ACCESSIBILITY CHECKLIST

For Restaurant and Bar at: 1 Newport Pier

Prepared by: Daniel Kennedy, Principal Civil Engineer
Certified Access Specialist Program Number: CASp - 198
Date: Nov 7, 2012
Project No.: 2012-001

Detail 9/A6

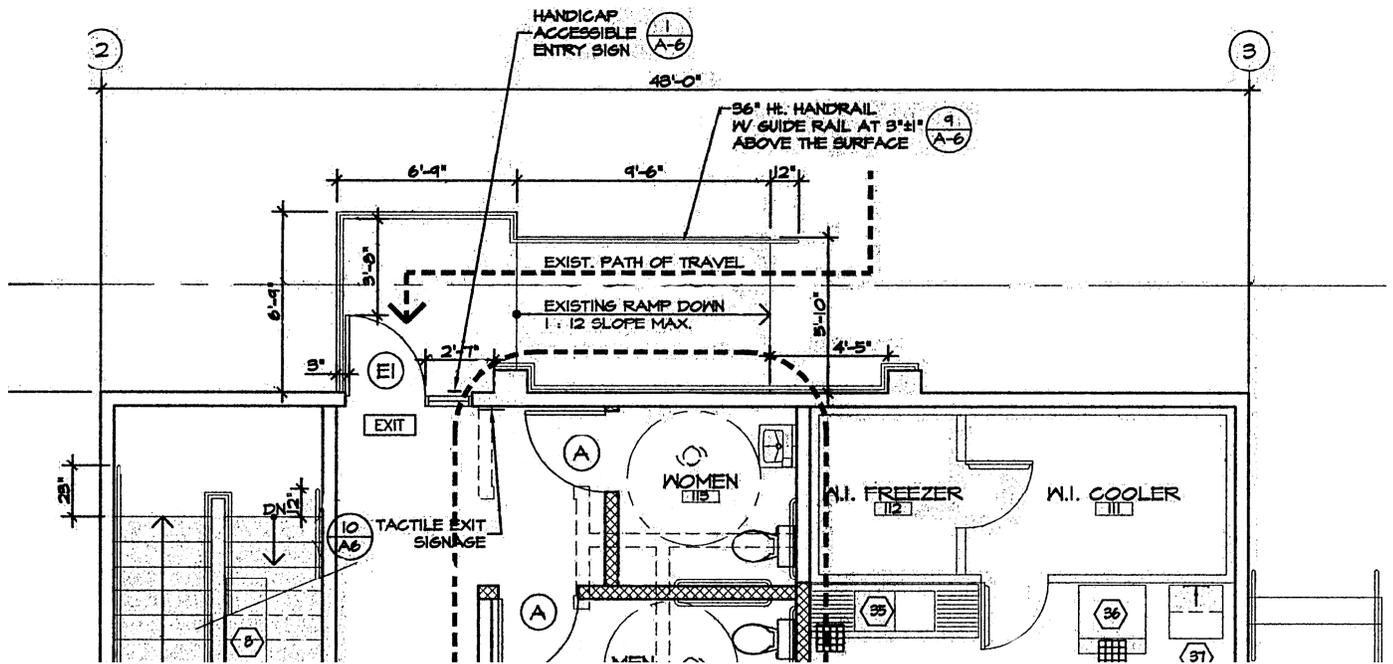
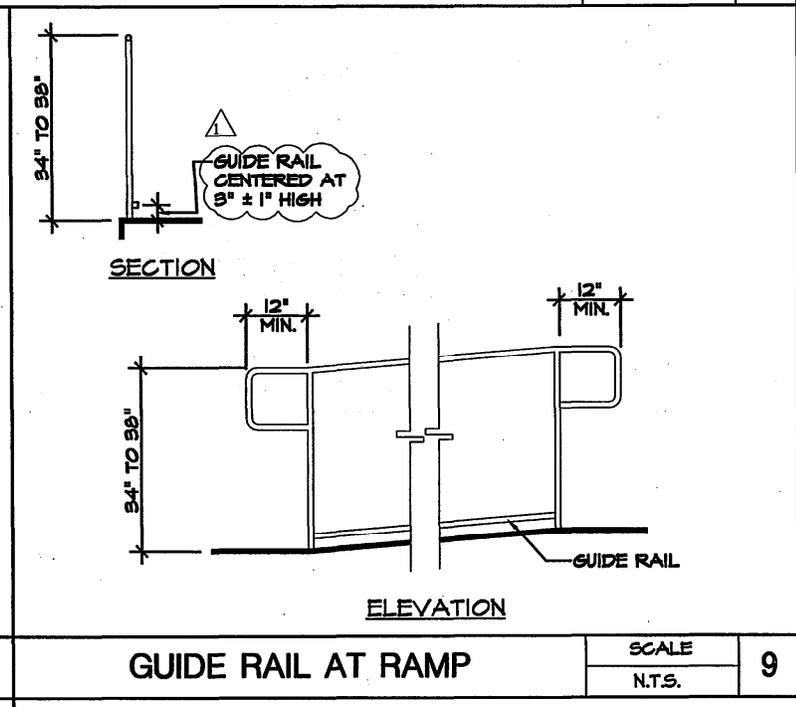
7.2	Slope	Is the slope of the curb ramp the least possible slope but in no case more than 8.3% (1:12)? 4.8.2 /// 1133B.5.3	Ramp could have been project out further.	See Sheet A3 of plan check 1436-2008	Yes <input type="checkbox"/> No <input checked="" type="checkbox"/> N/A <input type="checkbox"/>

7.5	Surface	Is the ramp surface stable, firm and slip-resistant? 4.8.6; 4.5 /// 1124B.1	Needs slip-resistant material.	See Sheet A3 of plan check 1436-2008	Yes <input type="checkbox"/> No <input checked="" type="checkbox"/> N/A <input type="checkbox"/>

7.10	Bottom Landing	Where the ramp does not change direction, is there a bottom landing at least 72" long and as wide as the ramp? 4.8.4 /// 1133B.5.4.2	Projections reduce provided width in two locations.	See Sheet A3 of plan check 1436-2008	Yes <input type="checkbox"/> No <input checked="" type="checkbox"/> N/A <input type="checkbox"/>

7.14	Edge Protection	If a ramp or landing has a drop off, does it have a minimum 2" curb, wheel guide, a wall, or fence to prevent people from falling off? 4.8.7 /// 1133B.5.4.9		See Sheet detail 9/A6 plan check 1436-2008	Yes <input checked="" type="checkbox"/> No <input type="checkbox"/> N/A <input type="checkbox"/>

7.18	Gripping Surface	Are the gripping surfaces continuous? 4.8.5(4) /// 1133B.5.5.1	Architectural projections reduce gripping.	See Sheet A3 of plan check 1436-2008	Yes <input type="checkbox"/> No <input checked="" type="checkbox"/> N/A <input type="checkbox"/>

7.21	Handrail Extension	At ends of handrails, are there at least 12" of handrail, parallel to the floor or ground surface, extending beyond the top and bottom of the ramp segment? 4.8.5(2) /// 1133B.5.5.1	Handrails do not continue in the direction of travel.	See Sheet A3 of plan check 1436-2008	Yes <input type="checkbox"/> No <input checked="" type="checkbox"/> N/A <input type="checkbox"/>

7.22	Ends of Handrails	Are the ends of handrails rounded or returned smoothly to the floor, wall, or post? 4.8.5(6) /// 1133B.5.5.1	Rounding begins and ends at the wrong locations	See Sheet A3 of plan check 1436-2008	Yes <input type="checkbox"/> No <input checked="" type="checkbox"/> N/A <input type="checkbox"/>

7.24	Clearance	Is the clear space between handrails and walls exactly 1-1/2"?" 4.26.2 /// 1133B.5.5.1	Exterior surface reduce clearance	See Sheet A3 of plan check 1436-2008	Yes <input type="checkbox"/> No <input checked="" type="checkbox"/> N/A <input type="checkbox"/>

First Floor Main Stairs

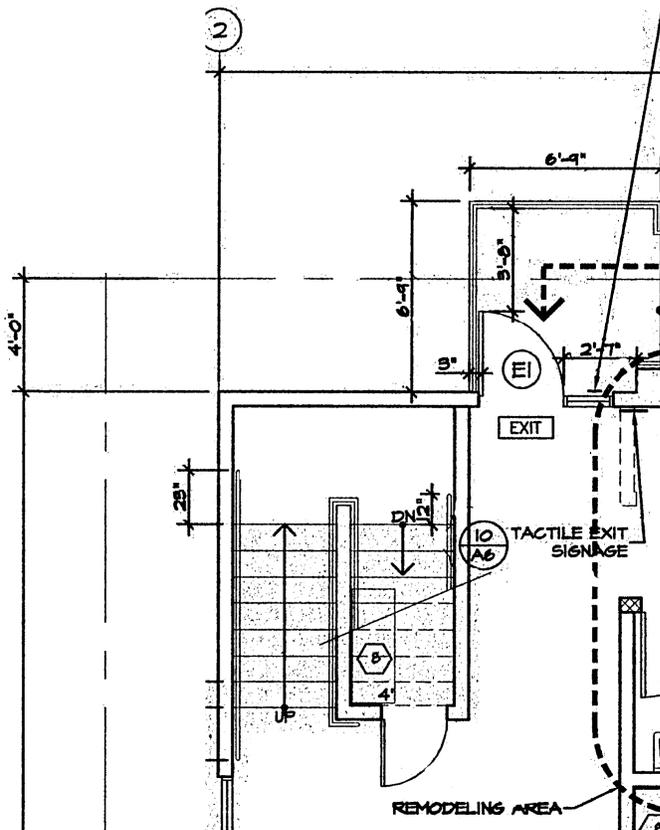
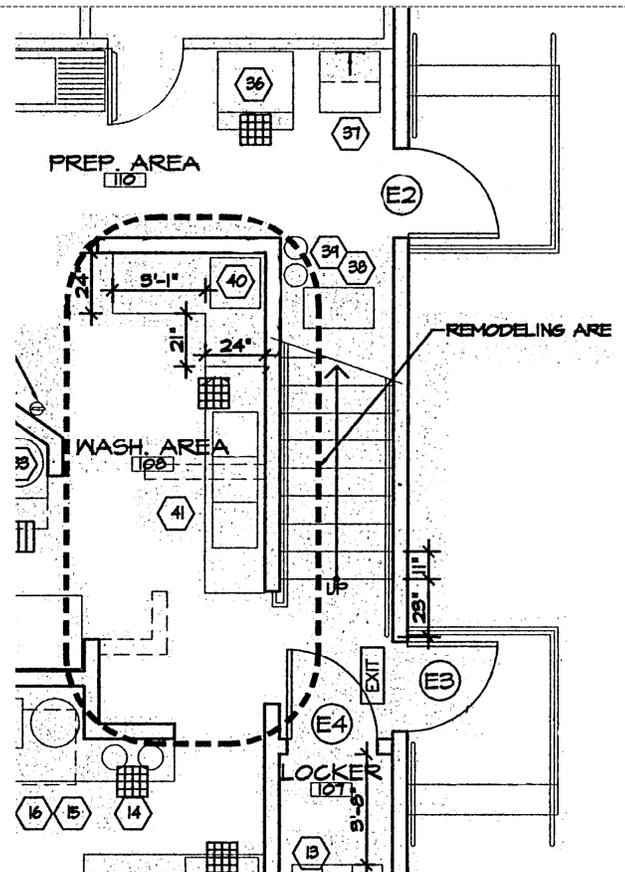
8.3	Risers/Treads	Are the treads uniform and at least 11" wide measured from riser to riser and are the risers all uniform and between 4" and 7" in height? 4.9.2 /// 1009.4, 1133B.4.5.1, 1133B.4.5.2	Treads are too small and Riser heights vary	See Sheet A3 & A4 of plan check 1436-2008	Yes <input type="checkbox"/> No <input checked="" type="checkbox"/> N/A <input type="checkbox"/>

8.7	Continuous Handrails	Are there continuous handrails along both sides? 4.9.4(1) /// 1133B.4.1.1	Plan show handrail but several are removed	See Sheet A3 & A4 of plan check 1436-2008	Yes <input type="checkbox"/> No <input checked="" type="checkbox"/> N/A <input type="checkbox"/>

8.8	Handrails	On dogleg or switchback stairs, is the inside handrail continuous at landings? 4.9.4(1) /// 1133B.4.2.2 Exception 1	Missing handrails	See Sheet A3 & A4 of plan check 1436-2008	Yes <input type="checkbox"/> No <input checked="" type="checkbox"/> N/A <input type="checkbox"/>

First Floor Main Stairs

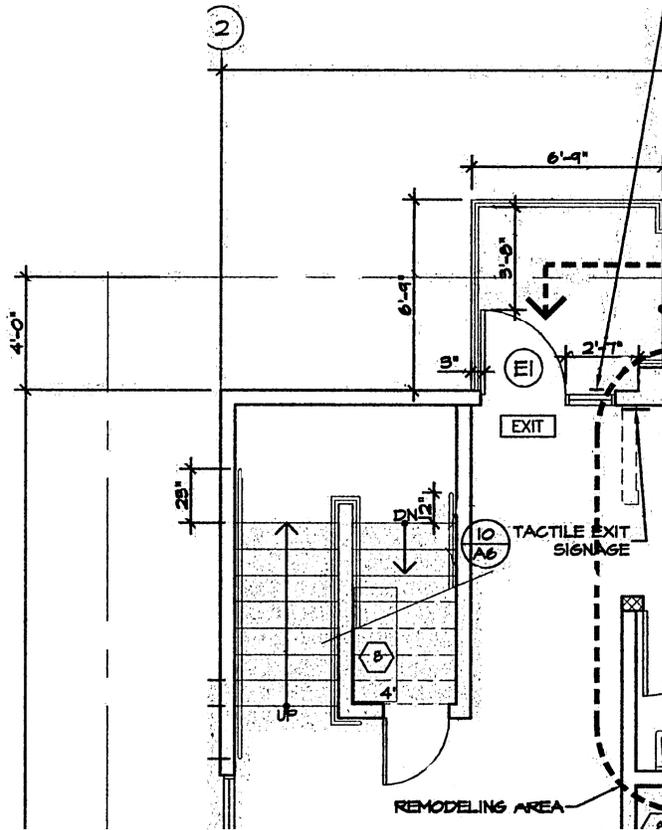
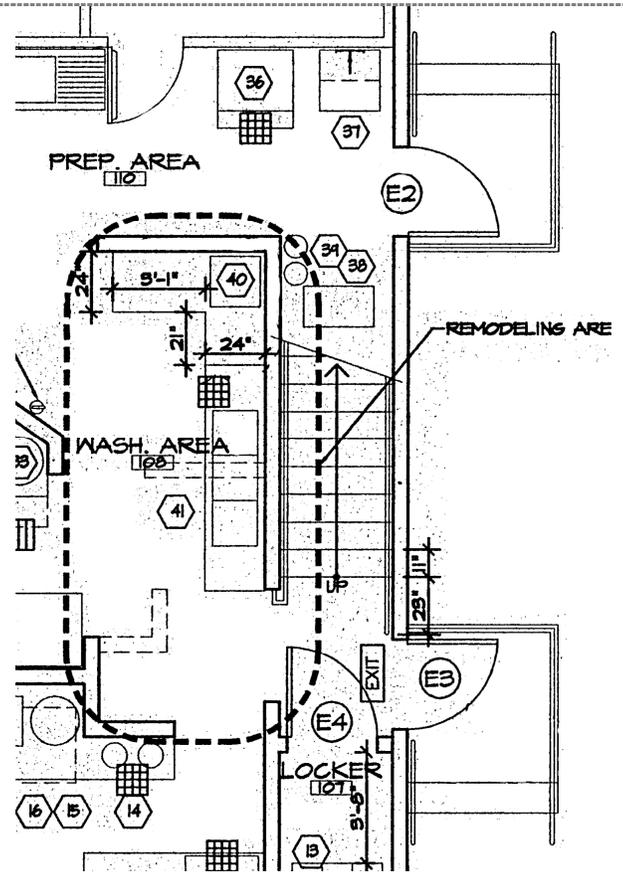
10.11	Door Operating Effort	Is the force required to operate a door no greater than 5 lbs? (Fire doors may have up to 15 lbs to achieve positive latching). 4.27.4 /// 1133B.2.5		See Sheet A3 & A4 of plan check 1436-2008	Yes <input type="checkbox"/> No <input checked="" type="checkbox"/> N/A <input type="checkbox"/>

First Floor Doors

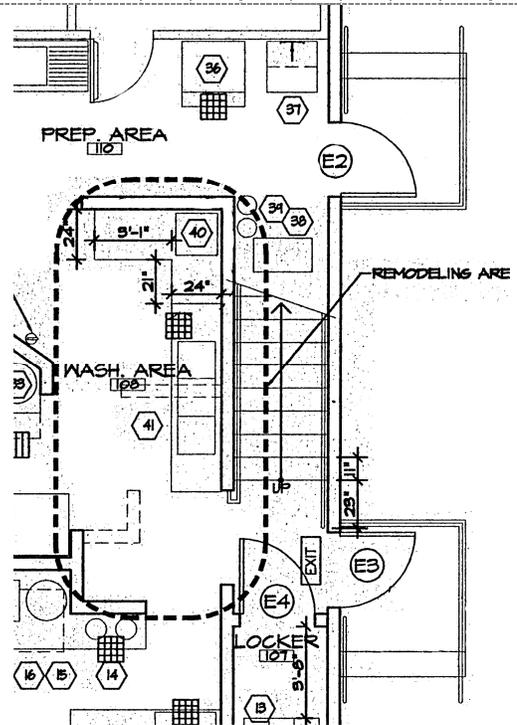
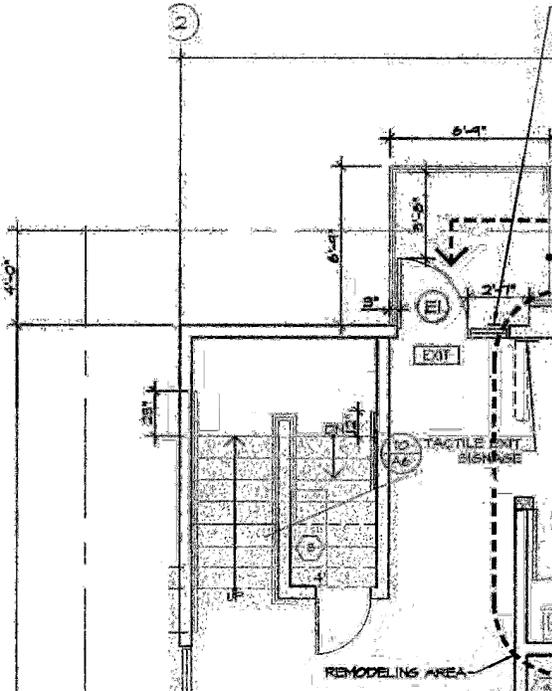
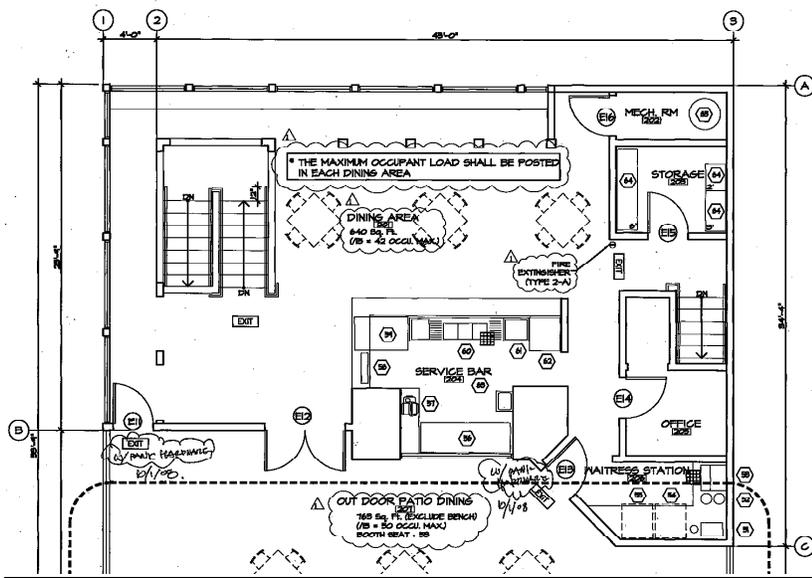
11.13	Door Operating Effort	Is the force required to operate a door no greater than 5 lbs? (Fire doors may have up to 15 lbs to achieve positive latching). 4.27.4 /// 1133B.2.5	Door E1 and E3	See Sheet A3 & A4 of plan check 1436-2008	Yes <input type="checkbox"/> No <input checked="" type="checkbox"/> N/A <input type="checkbox"/>

First Floor Plan

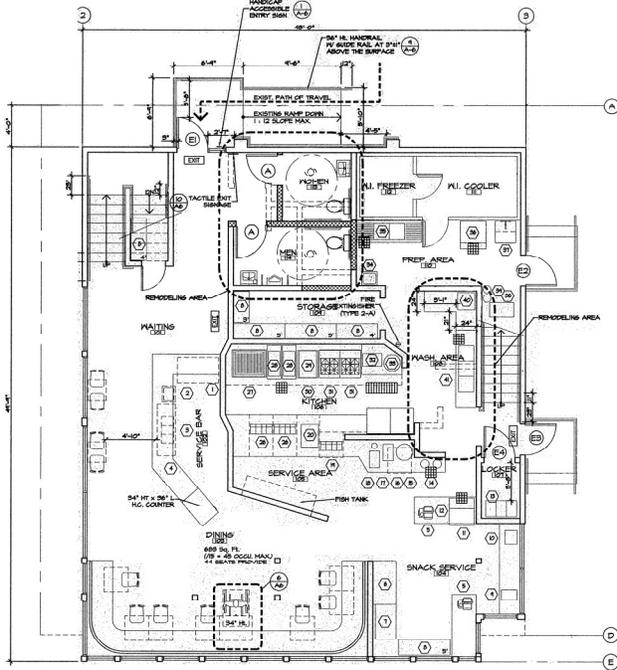
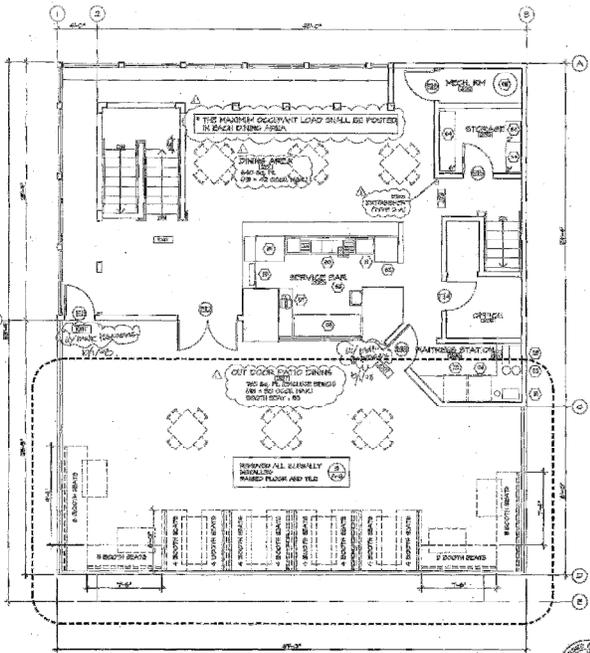
12.24A	Counter Height	At reception, transaction, or security counters, is there a portion of the main counter at least 36" long and no more than 34" high? 4.32.4 /// 1122B.4	Not within waiting area on 1st floor and not provided at 2 nd floor	See Sheet A3 & A4 of plan check 1436-2008	Yes <input type="checkbox"/> No <input checked="" type="checkbox"/> N/A <input type="checkbox"/>

12.26A	Changes in Level	Are ramps or elevators used for changes in level greater than 1/2"? 4.1.3(5) /// 1124B.2	Elevator required unless outdoor dining is provided on 1 st floor.	See Sheet A3 & A4 of plan check 1436-2008	Yes <input type="checkbox"/> No <input checked="" type="checkbox"/> N/A <input type="checkbox"/>

12.28A	Head room	Is there at least 80" clear head room within the pedestrian circulation area, including the accessible route of travel? 4.4.2 /// 1133B.8.6.2	Signage at 2 nd flr leading to side exit stairs is too low.	See Sheet A3 & A4 of plan check 1436-2008	Yes <input type="checkbox"/> No <input checked="" type="checkbox"/> N/A <input type="checkbox"/>

12.29A	Alarms	If emergency warning systems are provided, do they include both audible alarms and visual alarms complying with Survey Form 20 - Alarms? 4.1.3(14); 4.28 /// 907.5.2.1, 907.5.2.3, 1114B.2.2	Visual alarms not provided.	See Sheet A3 & A4 of plan check 1436-2008	Yes <input type="checkbox"/> No <input checked="" type="checkbox"/> N/A <input type="checkbox"/>
